## **CU Anschutz – Breckenridge Parking Lot Improvements**

**Project Number: 22-116457**

**Friday June 10, 2022  
ADDENDUM 1**

ED-102

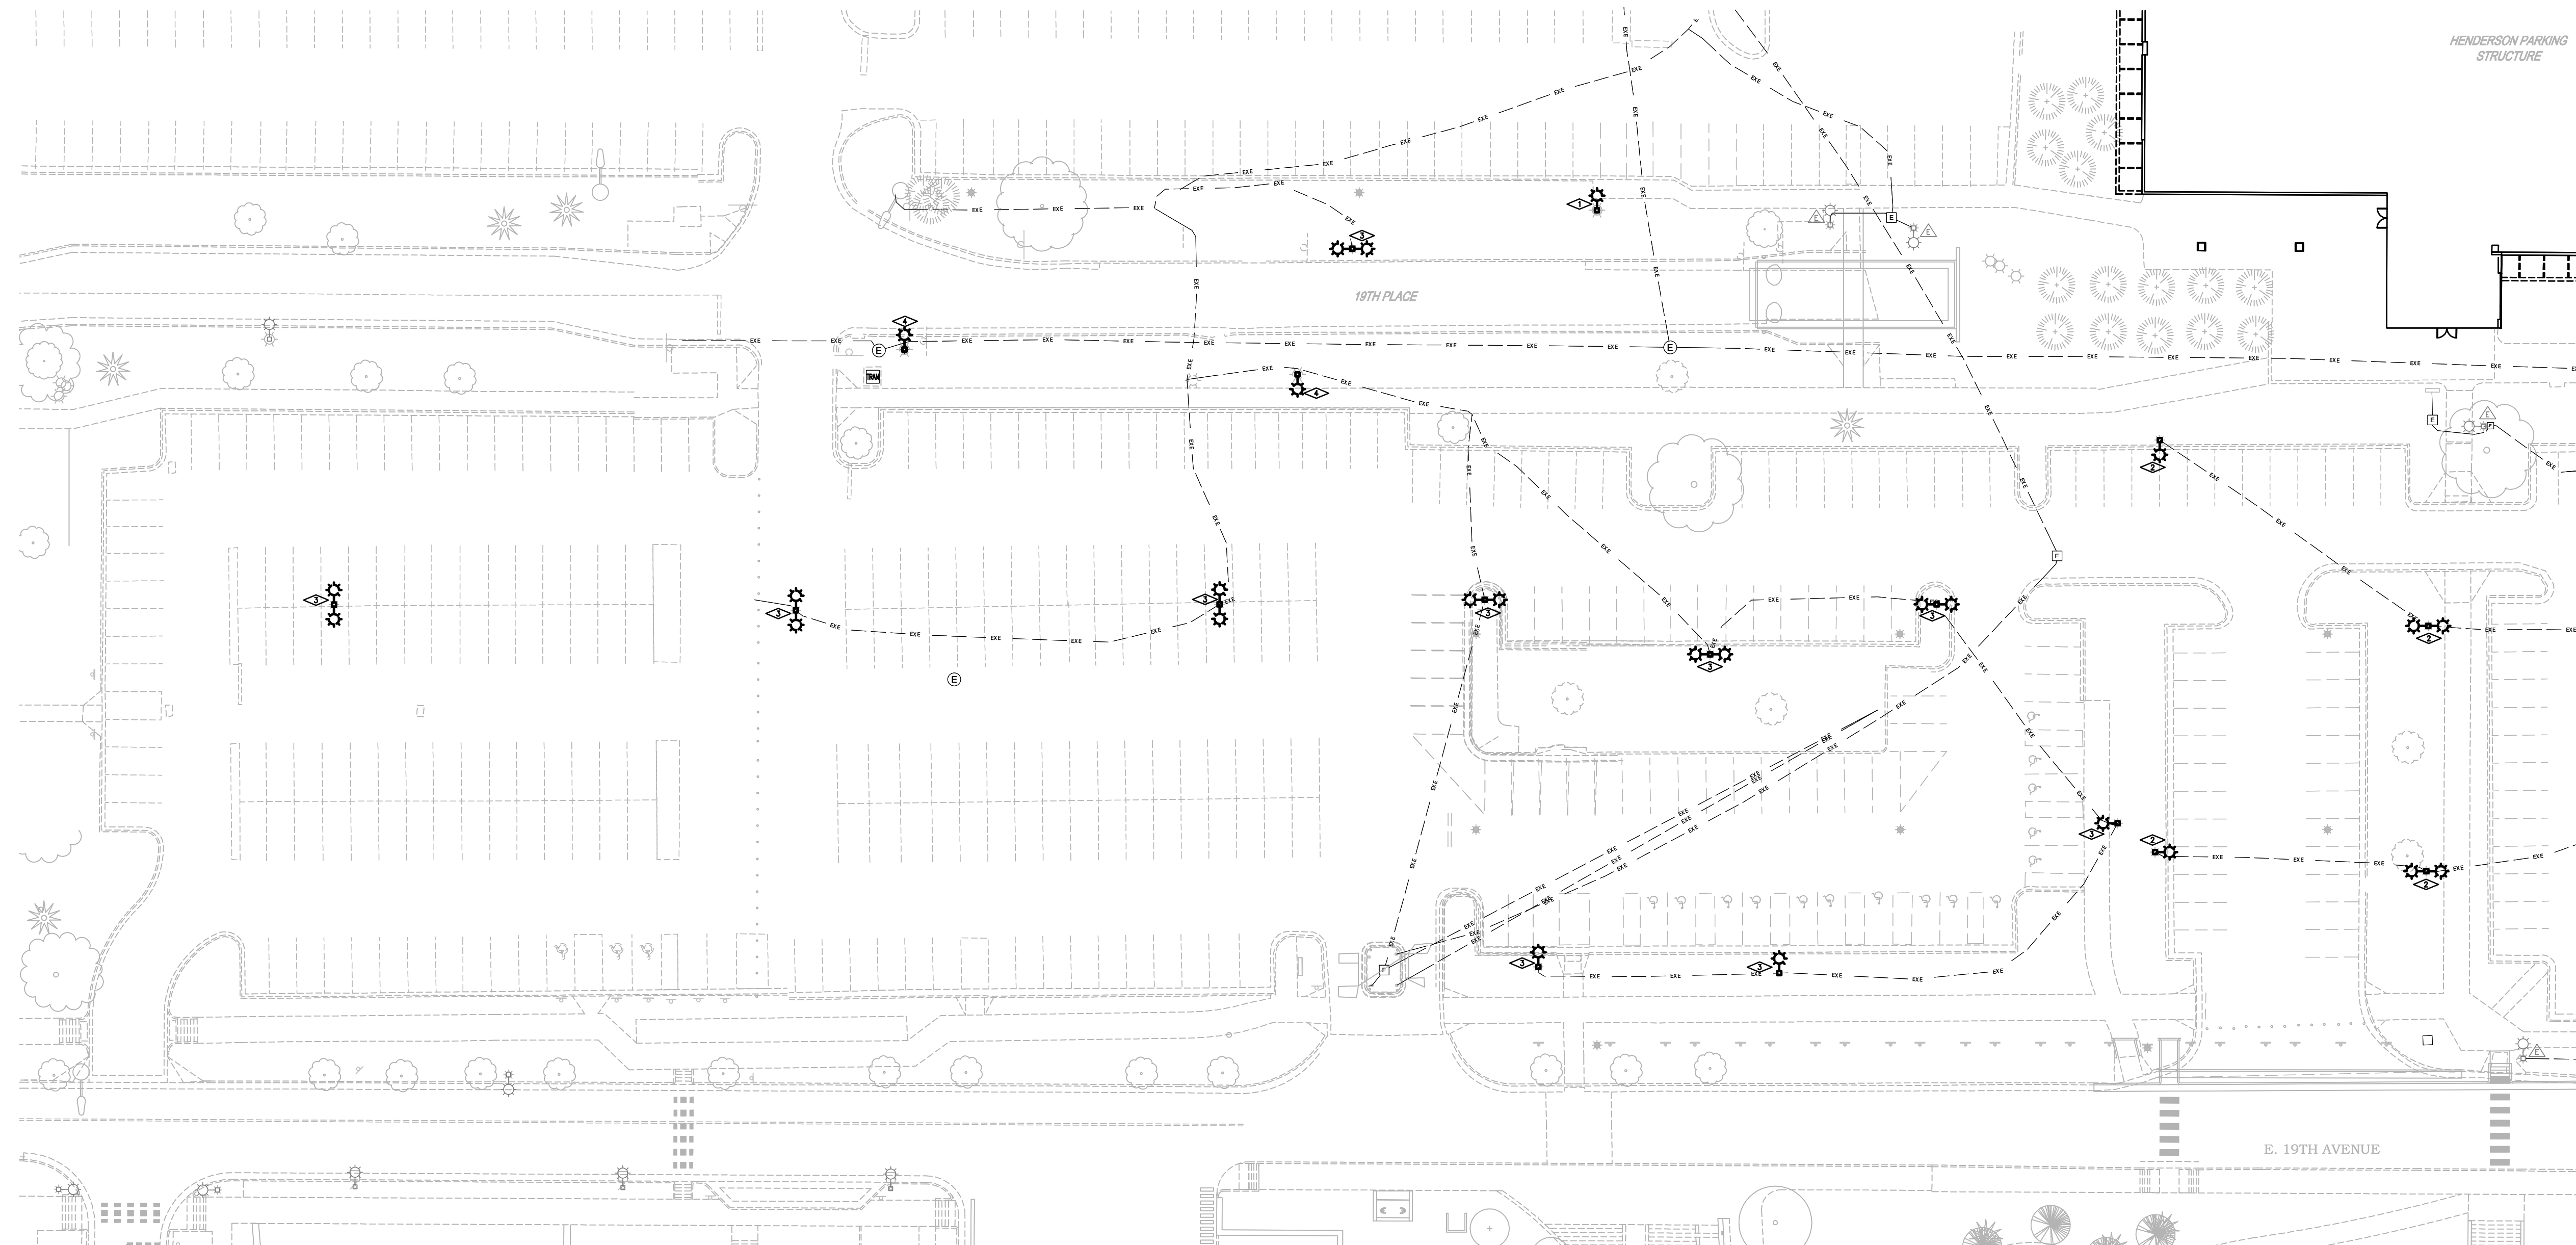
1. The following four (4) electrical drawing sheets have been revised and reissued to reflect expanded lighting scope, including head replacement for the re-used light poles and replacement of heads for the existing light poles within the parking lot west of the project site. These drawing sheets are attached to this addendum:

1. EXISTING POLE TO REMAIN. HEAD TO BE ROTATED. REFER TO NEW LIGHTING PLAN SHEET E-102 FOR ADDITIONAL INFORMATION.
2. POLE AND LED HEAD TO BE REUSED AND RELOCATED. REFER TO NEW LIGHTING PLAN SHEET E-102 FOR ADDITIONAL INFORMATION.
3. POLE TO BE RELOCATED. HEAD/HEADS ARE TO BE UPGRADED TO LED. REFER TO NEW LIGHTING PLAN SHEET E-102 FOR ADDITIONAL INFORMATION.
4. EXISTING COBRA HEAD LIGHT FIXTURE TO BE REMOVED.

E-102

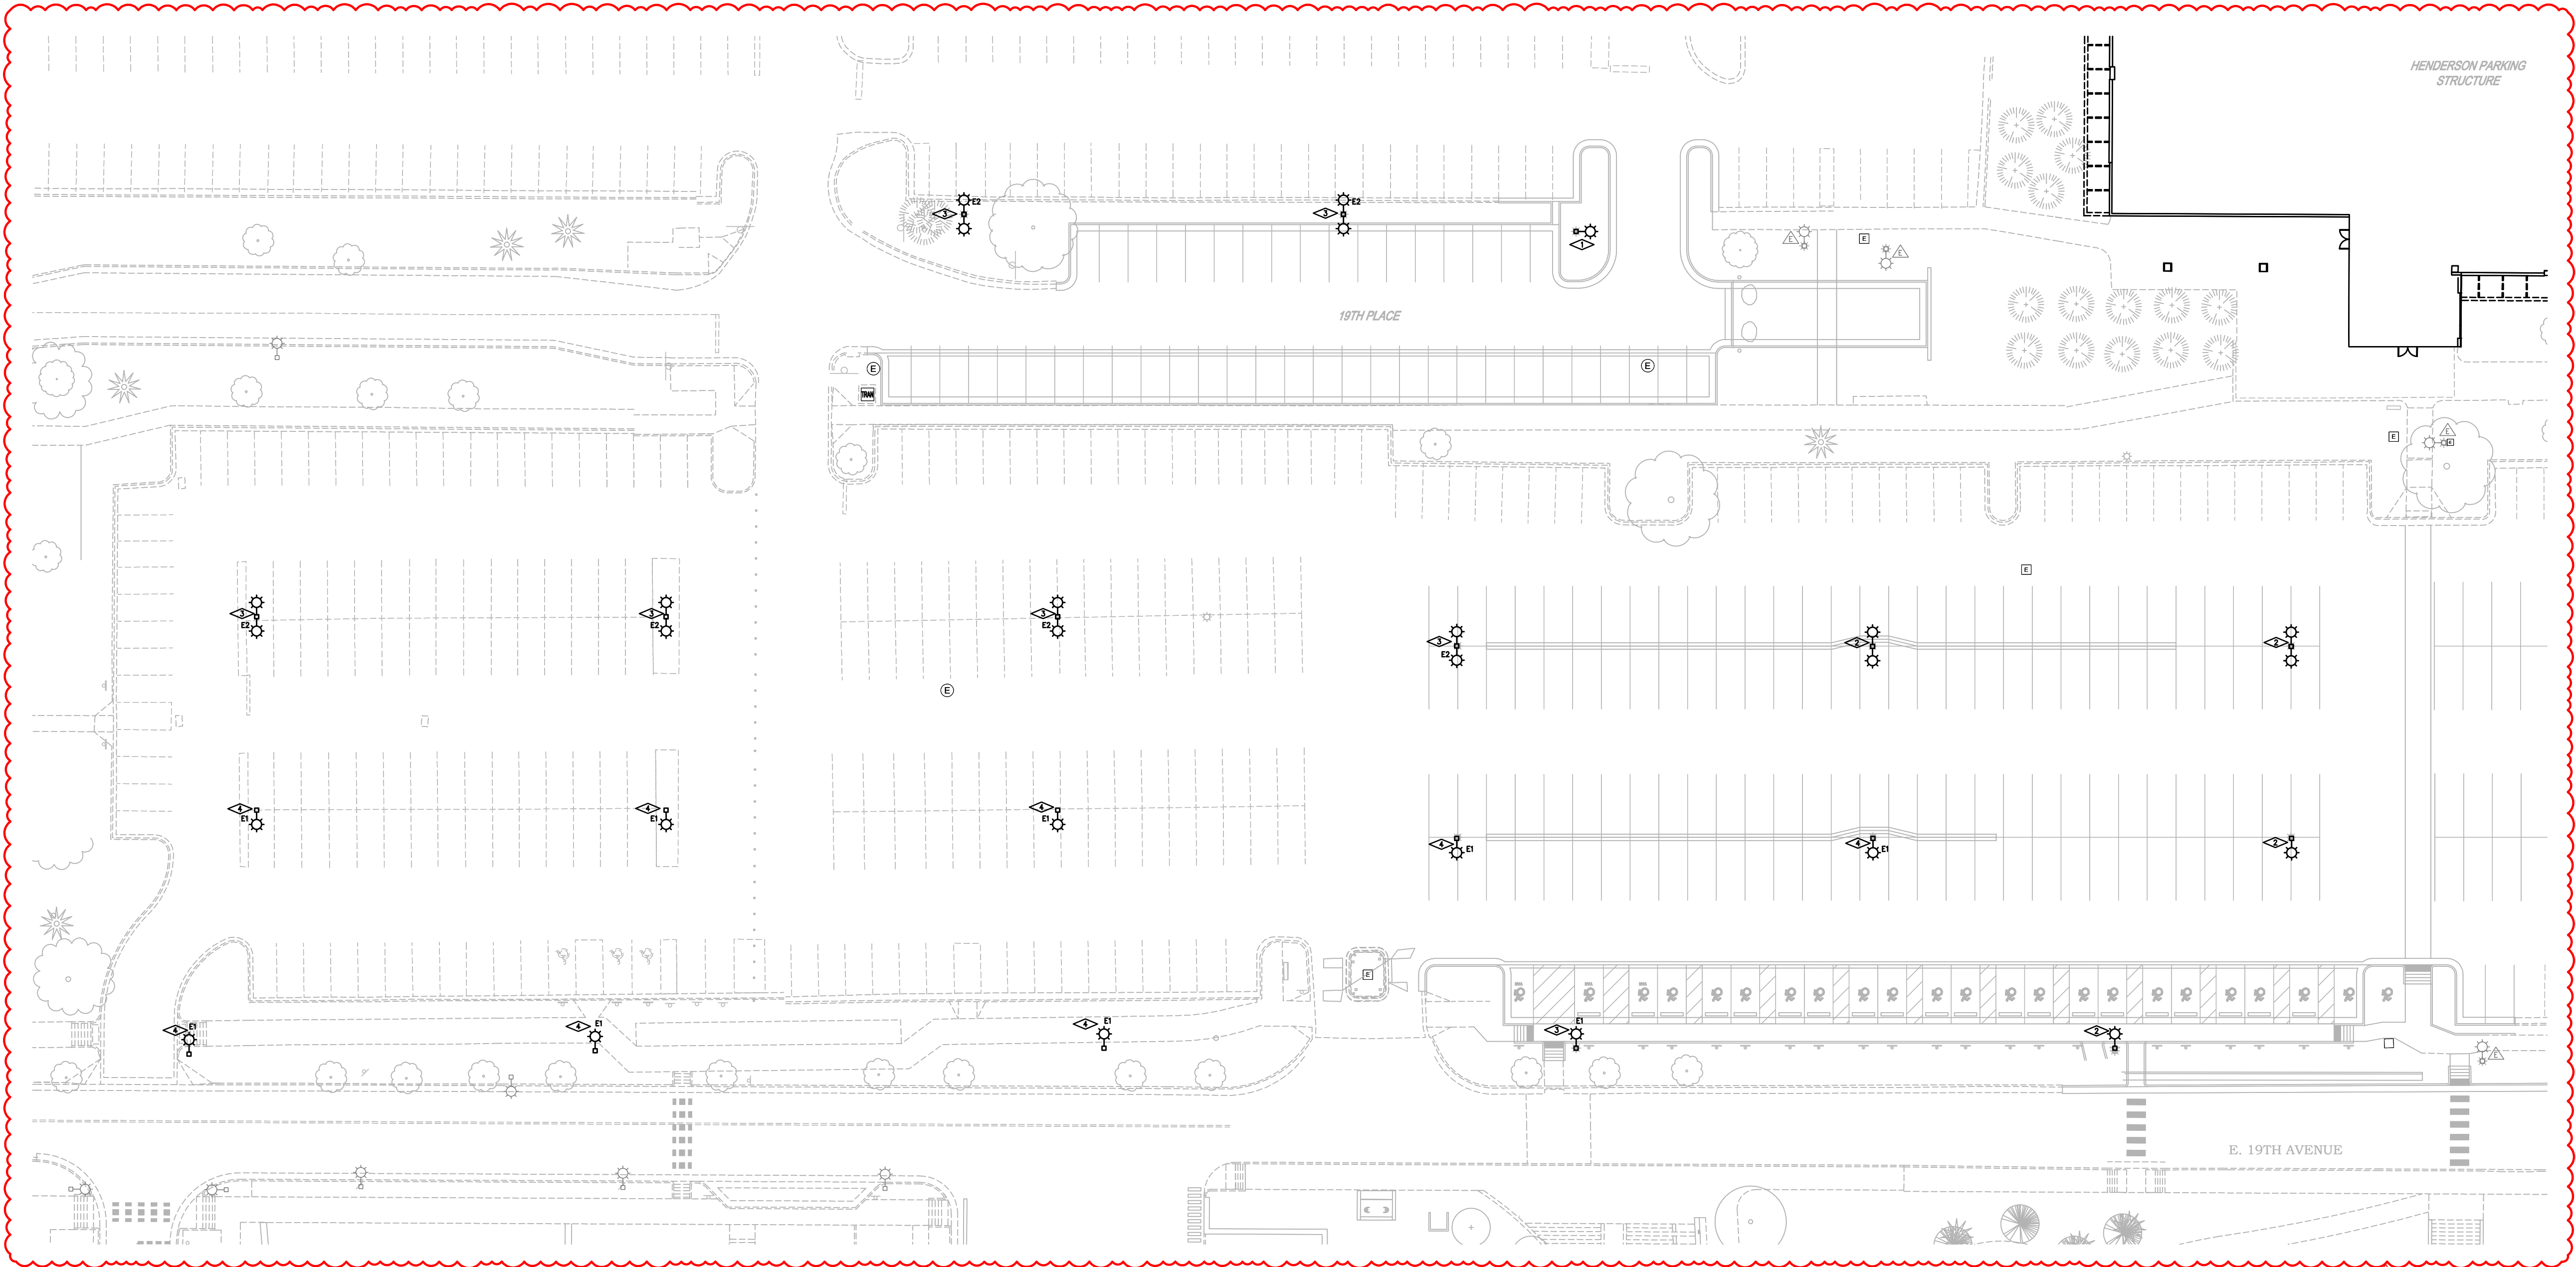
1. EXISTING POLE AND HEAD TO REMAIN. ROTATE EXISTING POLE/HEAD TO THE NEW DIRECTION SHOWN.
2. POLE AND LED HEAD TO BE REUSED AND RELOCATED. RECONNECT TO EXISTING CIRCUIT AND EXISTING LIGHTING CONTROL SYSTEM.
3. POLE TO BE RELOCATED. EXISTING HEAD/HEADS ARE TO BE UPGRADED TO LED. REFER TO LUMINAIRE SCHEDULE FOR MORE INFORMATION. RECONNECT TO EXISTING CIRCUIT AND EXISTING LIGHTING CONTROL SYSTEM.
4. NEW POLE AND NEW LED HEAD TO BE PROVIDED. REFER TO LUMINAIRE SCHEDULE FOR MORE INFORMATION. CONNECT TO NEAREST EXISTING PARKING LOT LIGHTING CIRCUIT AND EXISTING LIGHTING CONTROL SYSTEM.

**E-103**

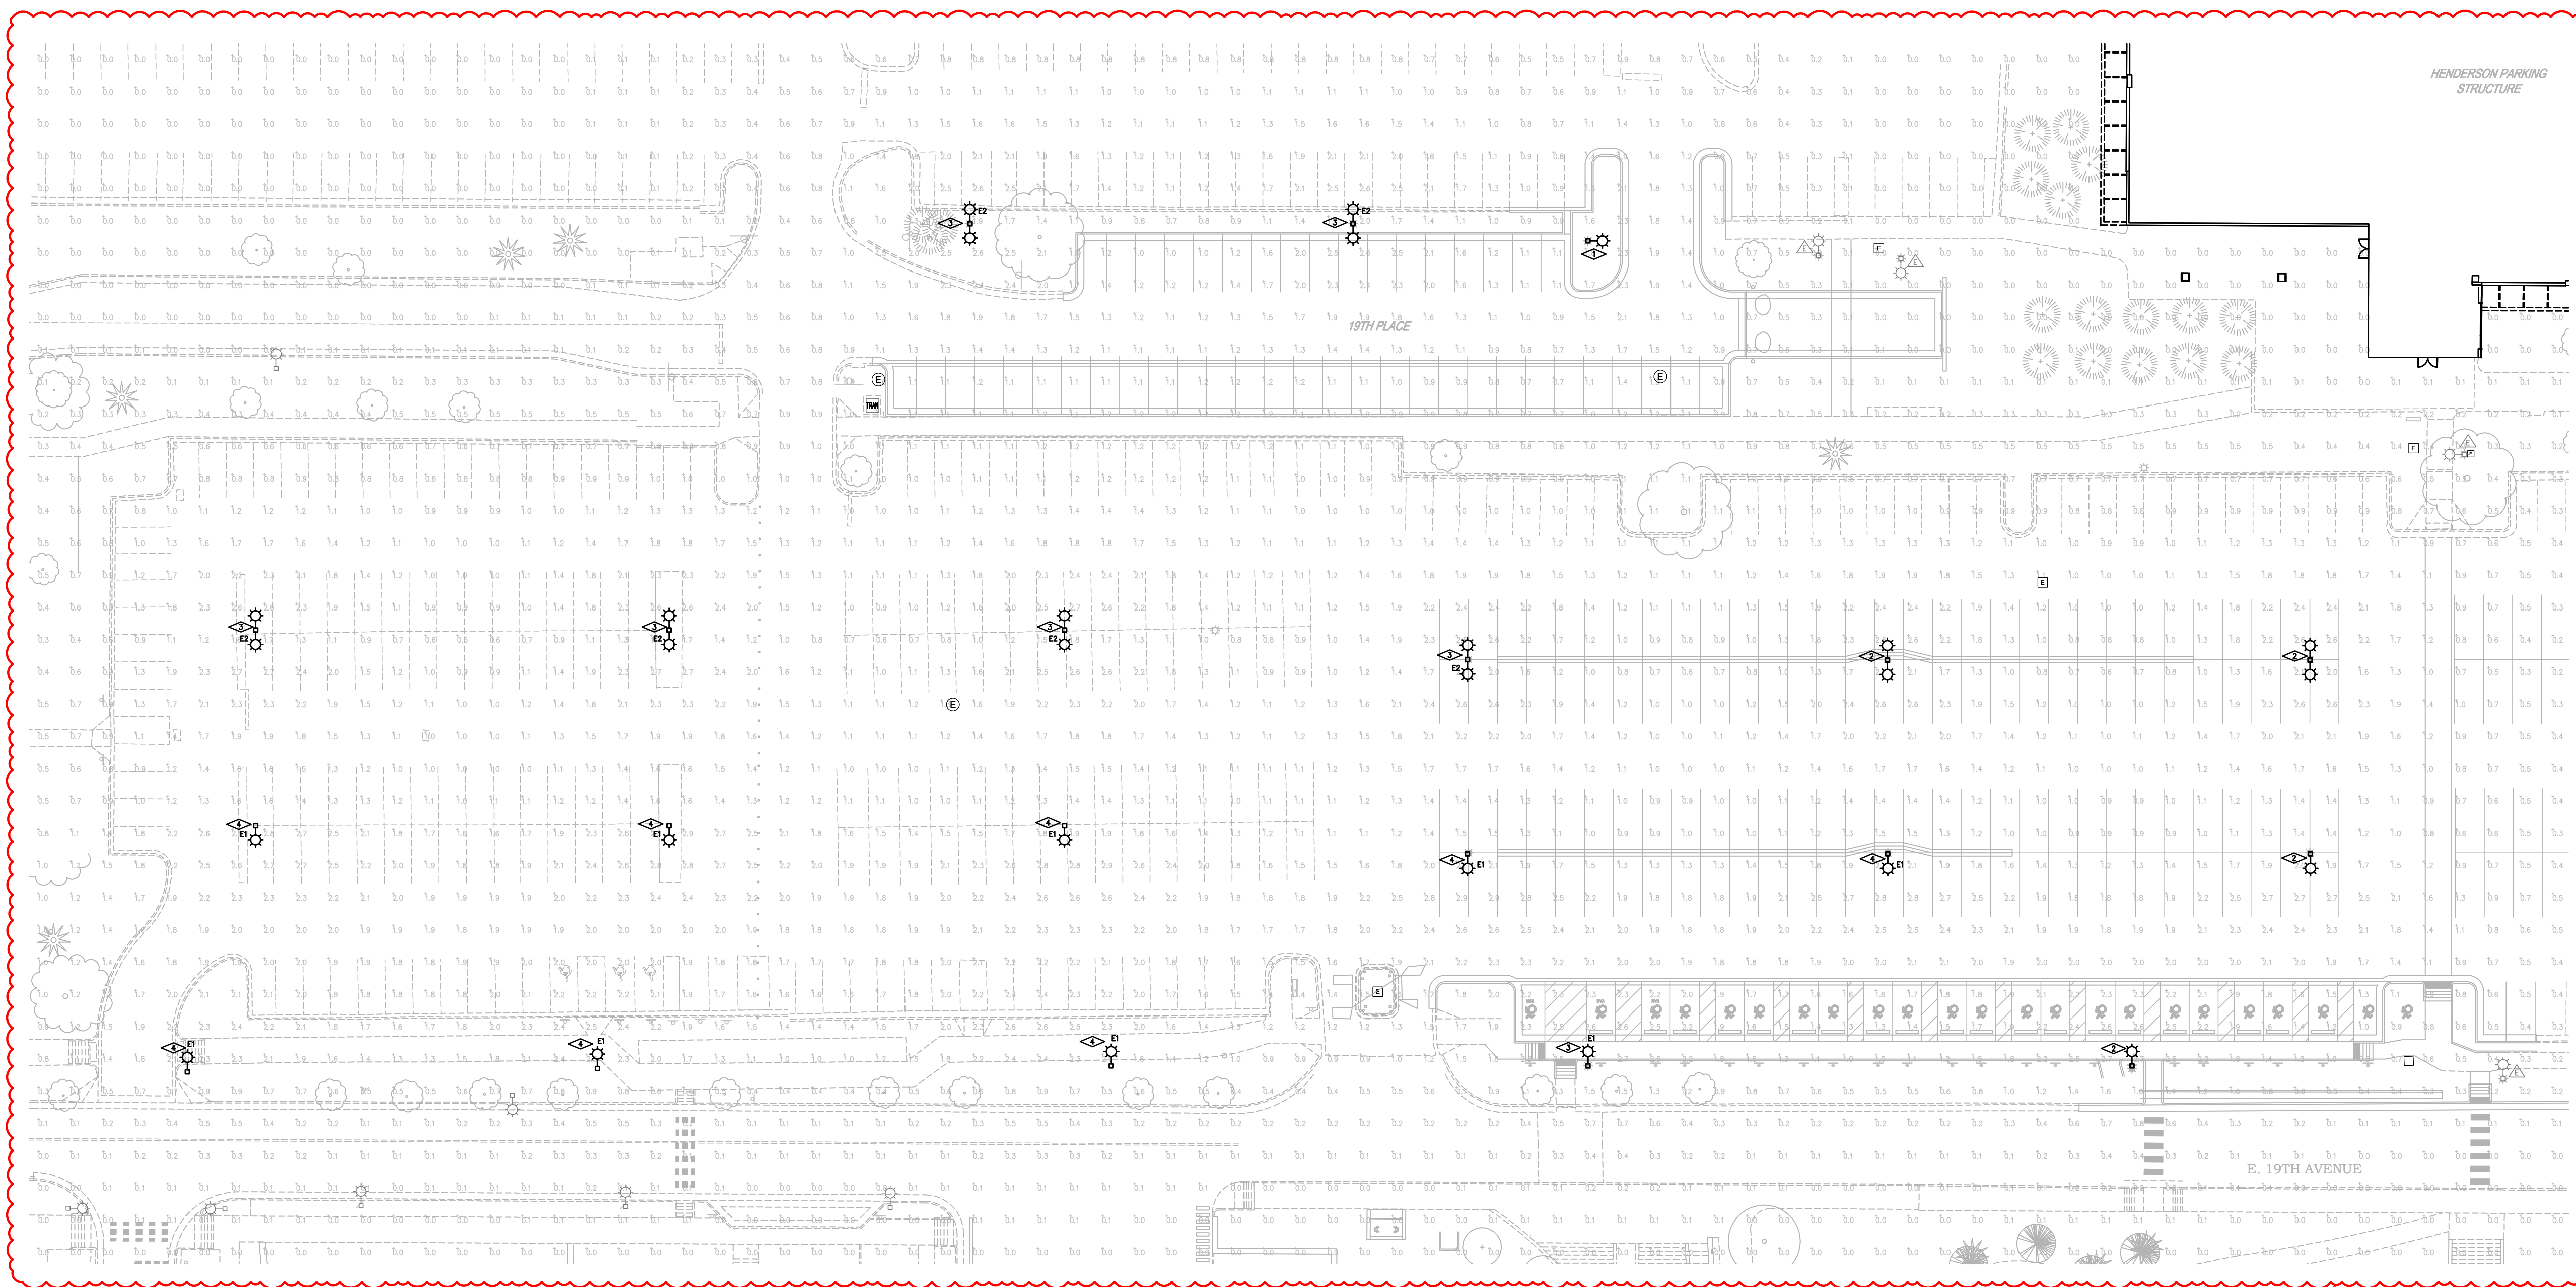
1. EXISTING POLE AND HEAD TO REMAIN. ROTATE EXISTING POLE/HEAD TO THE NEW DIRECTION SHOWN.
2. POLE AND LED HEAD TO BE REUSED AND RELOCATED. RECONNECT TO EXISTING CIRCUIT AND EXISTING LIGHTING CONTROL SYSTEM.
3. POLE TO BE RELOCATED. HEAD/HEADS ARE TO BE UPGRADED TO LED. REFER TO LUMINAIRE SCHEDULE FOR MORE INFORMATION. RECONNECT TO EXISTING CIRCUIT AND EXISTING LIGHTING CONTROL SYSTEM.
4. NEW POLE AND NEW LED HEAD TO BE PROVIDED. REFER TO LUMINAIRE SCHEDULE FOR MORE INFORMATION. CONNECT TO NEAREST EXISTING PARKING LOT LIGHTING CIRCUIT AND EXISTING LIGHTING CONTROL SYSTEM.
